### 10.3. Planning Proposal 9/22 and Voluntary Planning Agreement - 17-25 Falcon Street Crows Nest

The purpose of this report is to present to Council the assessment report for Planning Proposal 9/22 at 17-25 Falcon Street Crows Nest (which seeks to amend the North Sydney Local Environmental Plan 2013) and the accompanying Voluntary Planning Agreement offer.

FIGURE 6: Revised Building Height (Applicant's response to NSLPP recommendations, p.4)

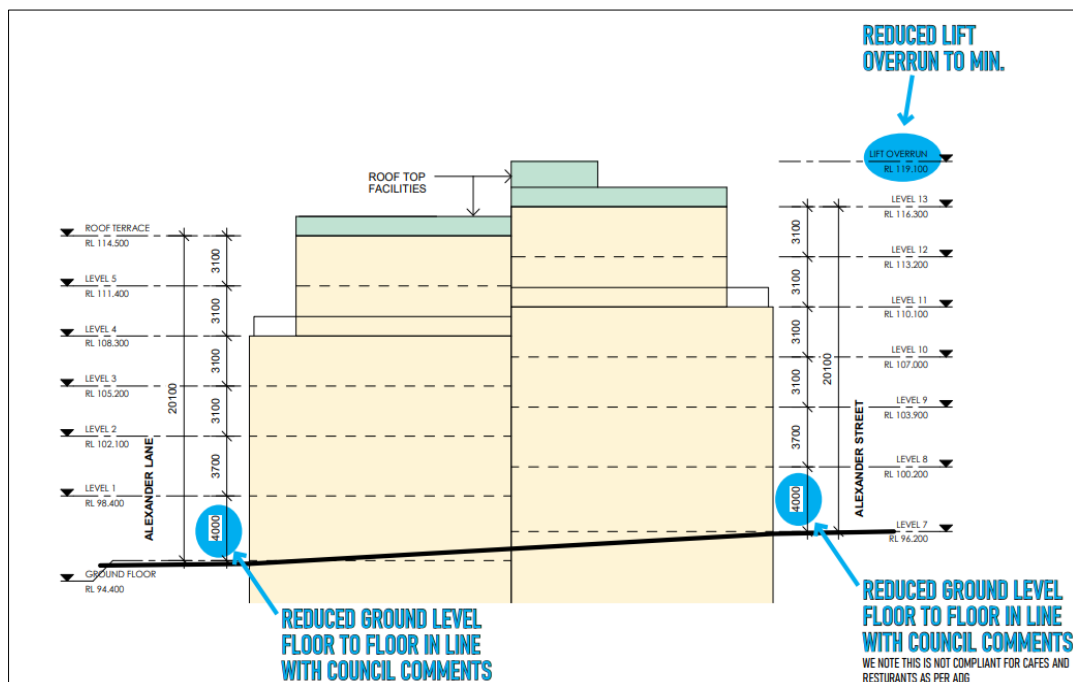
Council's detailed assessment report had raised concerns with the overall building height of 26.8m reflected within the applicant's reference scheme, which was considered excessive for a six-storey building as envisaged under the CPPS for the site and would result in a greater level of impact (overshadowing, visual) than necessary. In particular, a significant portion of the upper level exceeded the requested 21m maximum building height control, and the height and design of the proposed lift overrun/roof plant was considered excessive.

The applicant presented a revised building envelope in response to the NSLPP recommendation, as shown in Figure 6 below, which indicates a reduced overall building height of 24.7m inclusive of rooftop structures/facilities, with a predominant height of 21.9m for six storeys, which complies with the height recommendations of the NSLPP. The

reduction in the overall building height has been derived by stepping the built form to follow the sloping topography of the site, reducing the floor-to-floor height of the ground level, and reducing the height of rooftop facilities, which is supported.

FIGURE 7: 22m Height Plane  
(Applicant's Request for Additional Building Height of 500mm dated 19 January 2024 p. 6)

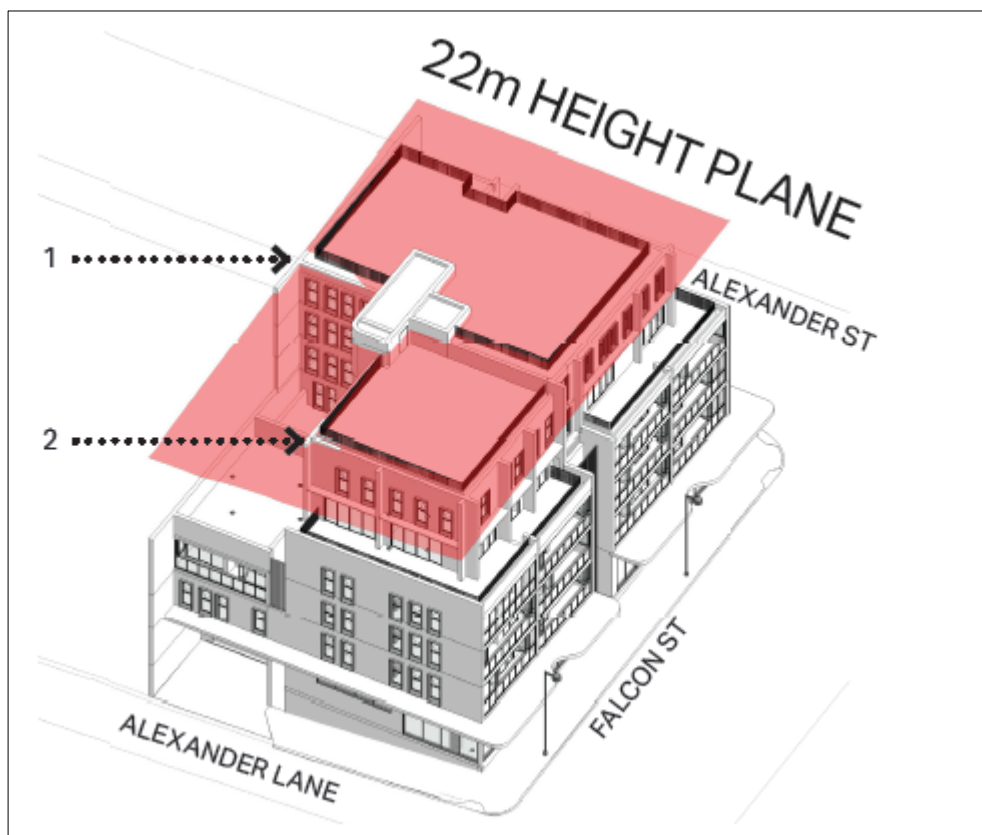
Figure 7 below details the level of exceedance to the recommended 22m building height below:

Figure 7 above indicates that the level of exceedance to the 22m building height is limited to two very small portions of the roof. It is not considered necessary to increase the Height of Building control by 0.5m to address a potential non-compliance of this degree. Whilst it is best practice to provide a proof of concept that can demonstrate compliance with the proposed built-form controls, non-compliances of this nature and magnitude can be addressed through existing mechanisms, specifically Clause 4.6 within the NSLEP 2013, at the detailed development application stage if required. Whilst a 0.5m increase to the

In response to the additional information received, Council's assessment has found that a building of a height of 22.5 metres is greater than is warranted for a six-storey mixed-use building. Council, in its determination of building height, applies consistent built-form controls which consider minimum floor-to-floor heights as specified by the ADG and similar building typologies.

The NSLPP acknowledged the significant cross-fall across the site from north-west to south-east is a constraint in achieving a six-storey mixed-use building under 21 metres and as a consequence recommended a 22m building height. This is the same building height to a recent planning proposal (also for a six-storey mixed-use development on a sloping site) at 12-14 Waters Road Neutral Bay.

FIGURE 8: Revised building envelope (Applicant's response to NSLPP recommendations, p. 12)

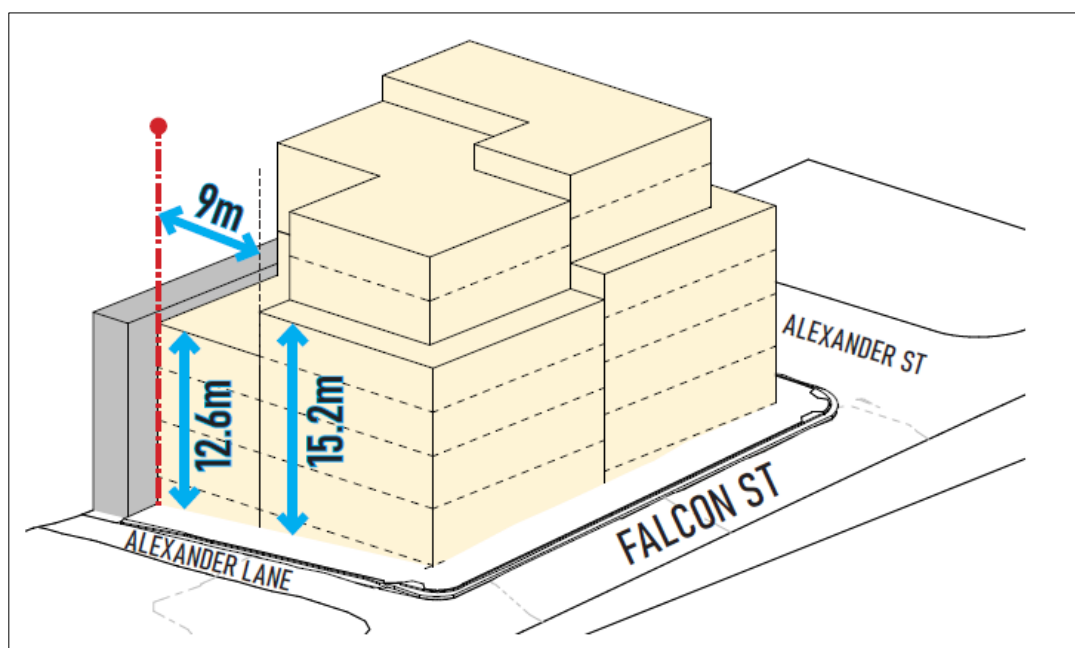
The applicant's revised building envelope, as detailed in Figure 8 below, incorporates reduced floor-to-floor heights; a stepped built form better responding to the topography of the site; an increased setback of nine metres above the podium to the southern boundary; and a reduction to the podium height along Alexander Lane (ranging from 12.6 – 15.2 metres in height).

Whilst the podium to Falcon Street remains 4-storeys, contrary to the three-storey podium requirements of NSDCP 2013, the applicant has attempted to justify this by emphasising the importance of urban continuity and referencing the adjacent approved development at 27-57 Falcon Street, which is currently under construction and of a similar scale and proportion. It is considered that the amended built form largely addresses the concerns raised and can be further refined at the future detailed Development Application stage.

**Figure 2a:** Proposed building height – 21 metres (Falcon Street Elevation)

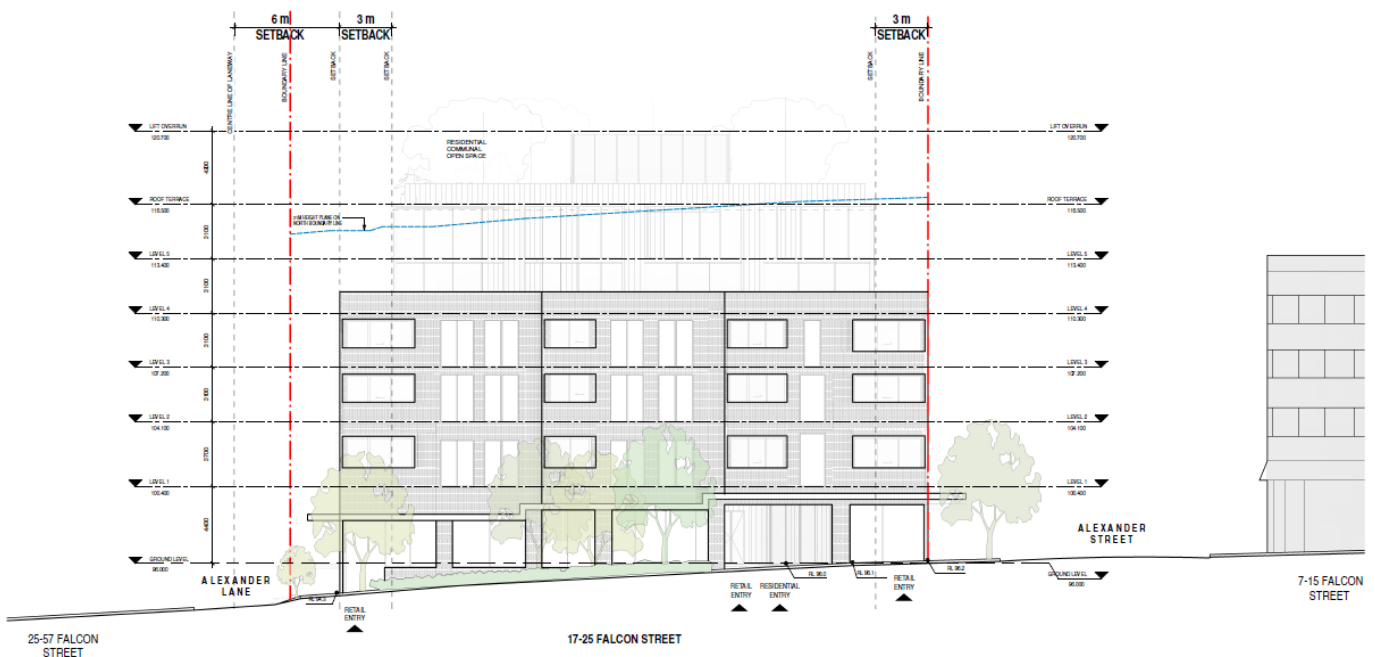
It should be noted that the subject site exhibits considerable cross fall and the proposed 21 metre height limit will enable the bulk of a six (6) storey building to be accommodated within this height limit. However, due to significant cross fall, a development application may need to include a supportable cl. 4.6 request for variation to permit a height exceedance for a portion of the uppermost floor.

# TEST A 22M HEIGHT PLANE + 3M LIFT OVERRUN & ROOFTOP FACILITIES HEIGHT PLANE

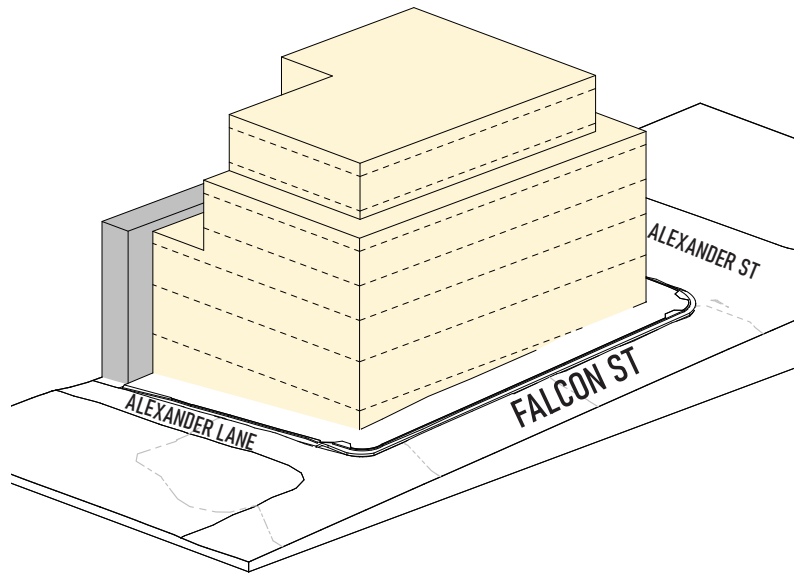
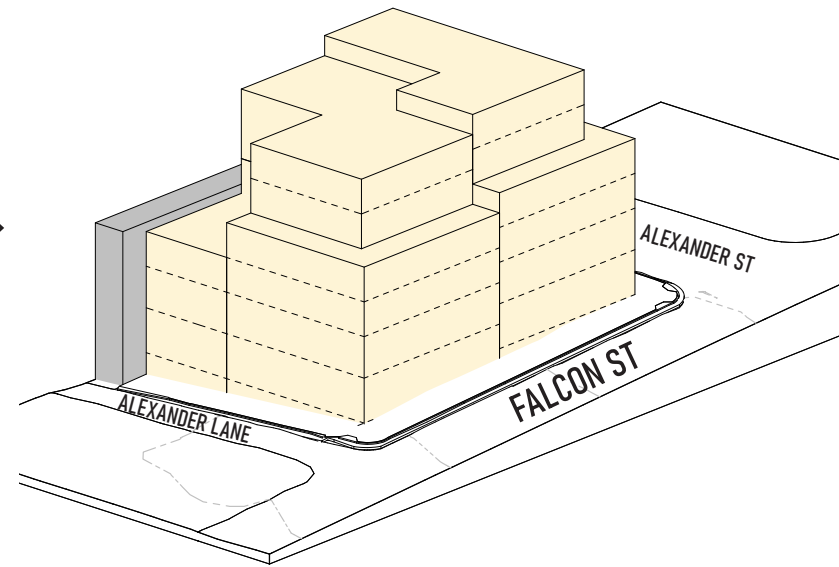
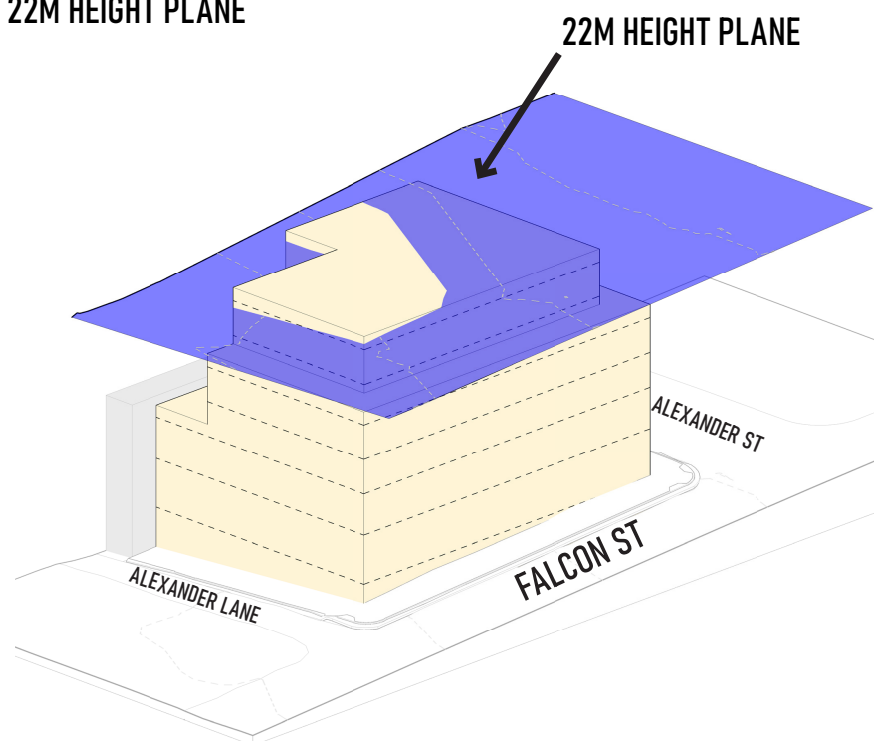
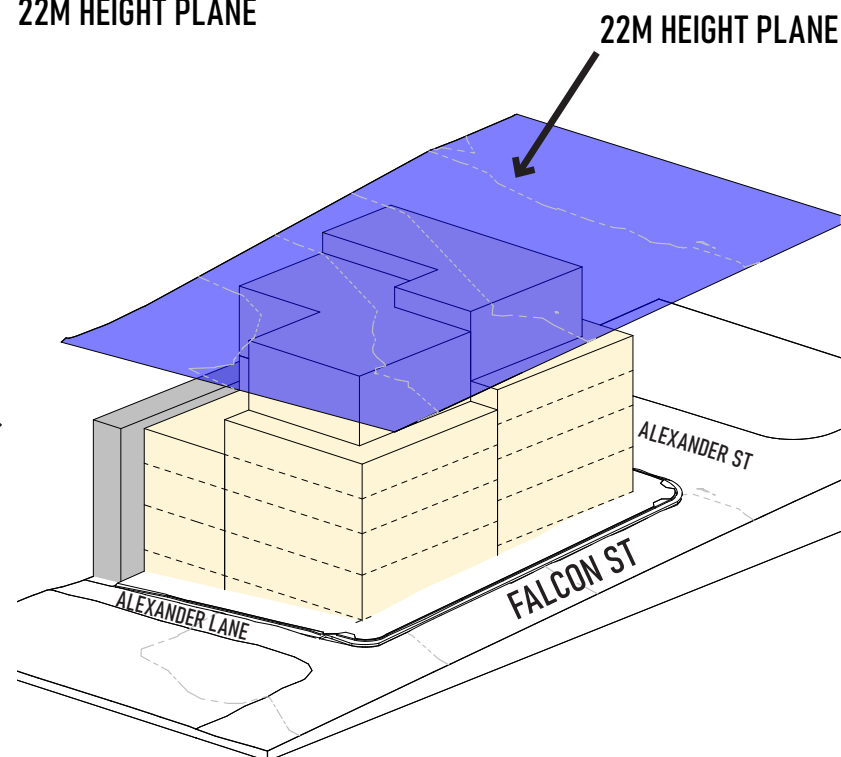
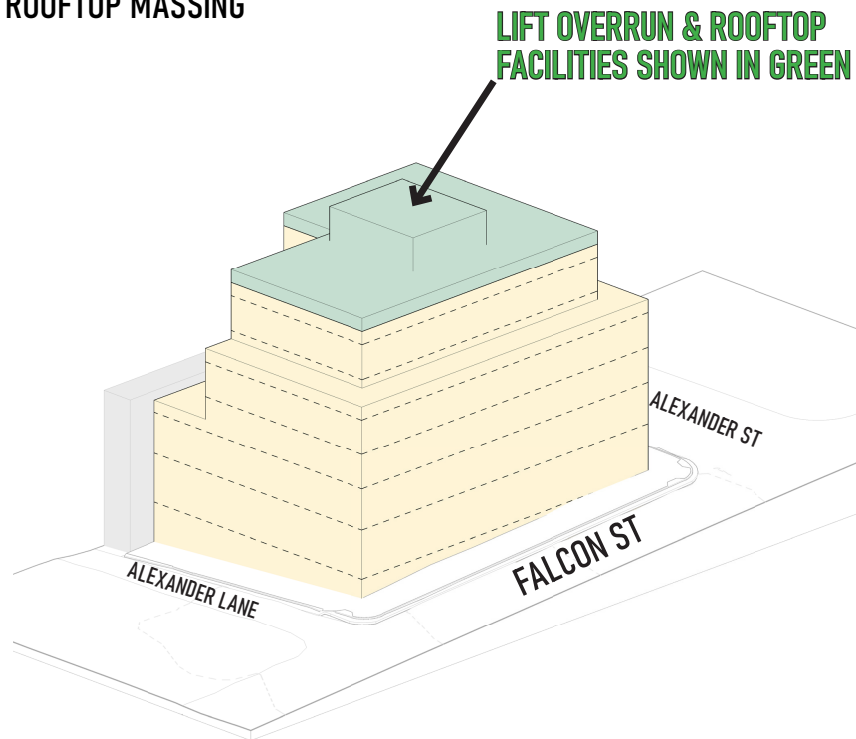
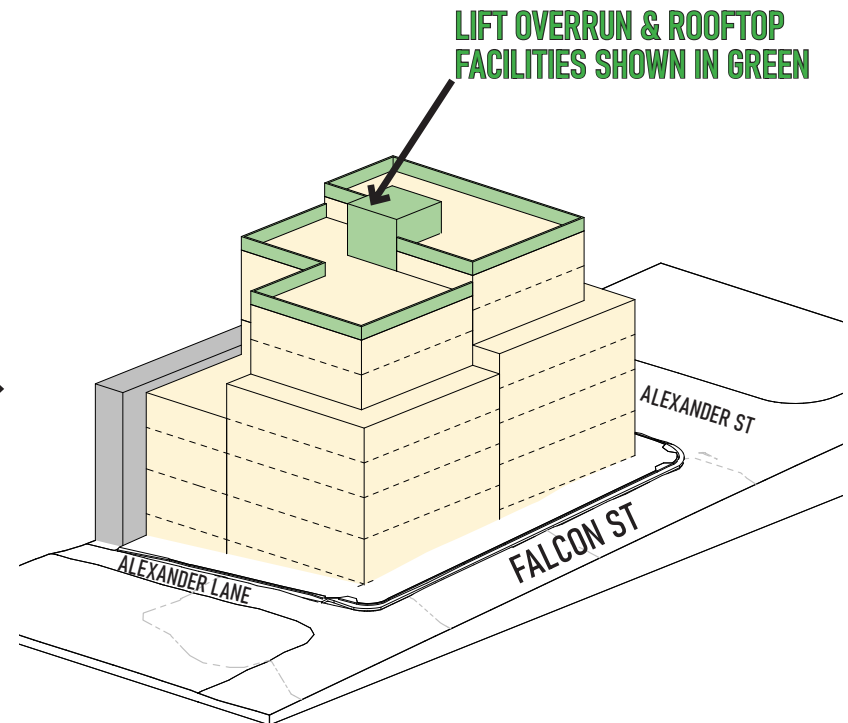
- REVIEW THE EXISTING FLOOR LEVELS INCLUDING THE GROUND FLOOR SET OUT POINT AND LIFT OVERRUN
- TEST A 22M HEIGHT PLANE + 3M LIFT OVERRUN HEIGHT PLANE
- EXPLORE PODIUM HEIGHTS AND NUMBER OF STOREYS
- REVIEW SETBACKS ABOVE PODIUM
- OMIT LOWER GROUND FLOOR RETAIL/ COMMERCIAL SPACE AND REVIEW BASEMENT LAYOUT
- TEST THE TOTAL GFA AND FSR

**Figure 2 Exceedance (green) of ADG compliant building with 22m HOB plane (red)**  
Source: Drew Dickson Architects

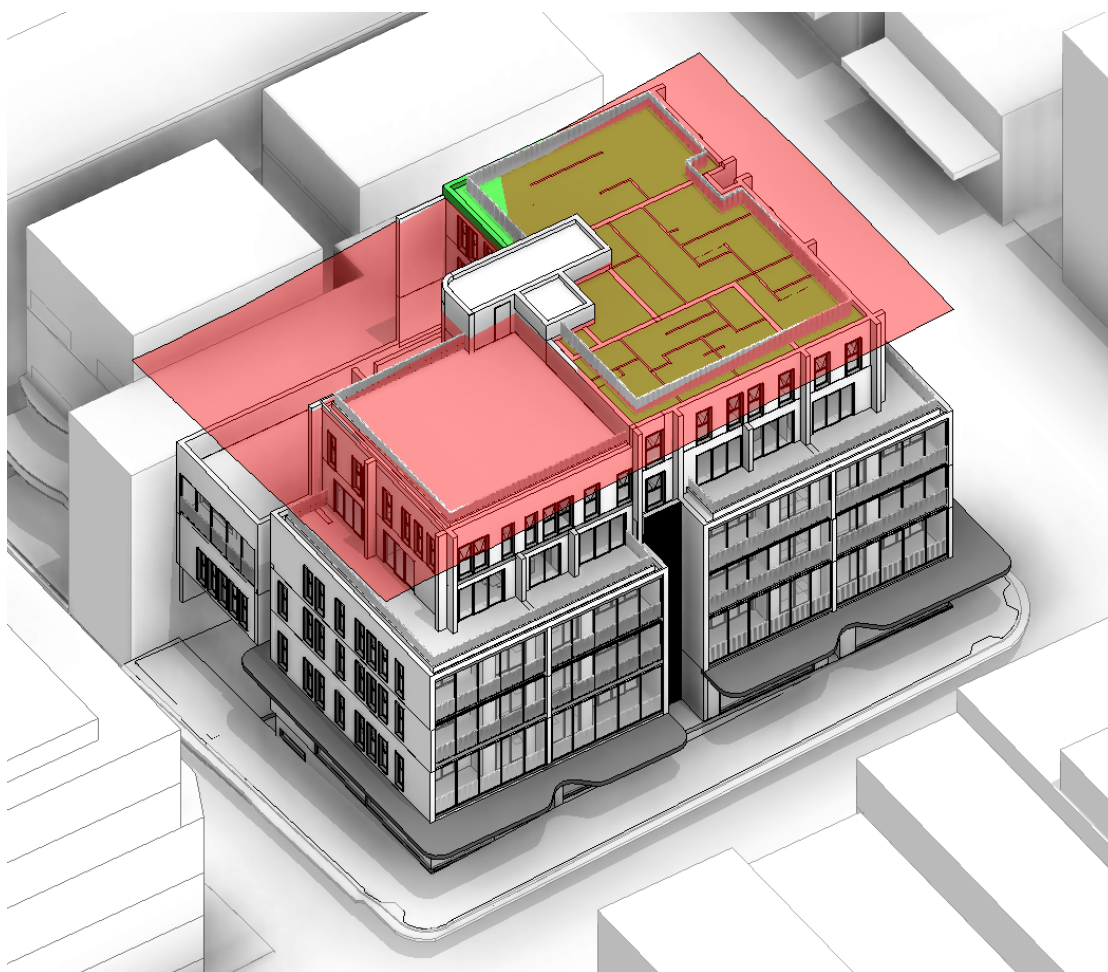
This change results in an additional 0.2m of floor to floor height at level 3, and an additional 0.3m of floor to floor height at level 5, totaling 0.5m of additional building height for the building. Therefore a **Height of Building control of 22.5m** is proposed – see **Figure 3 & 4**.
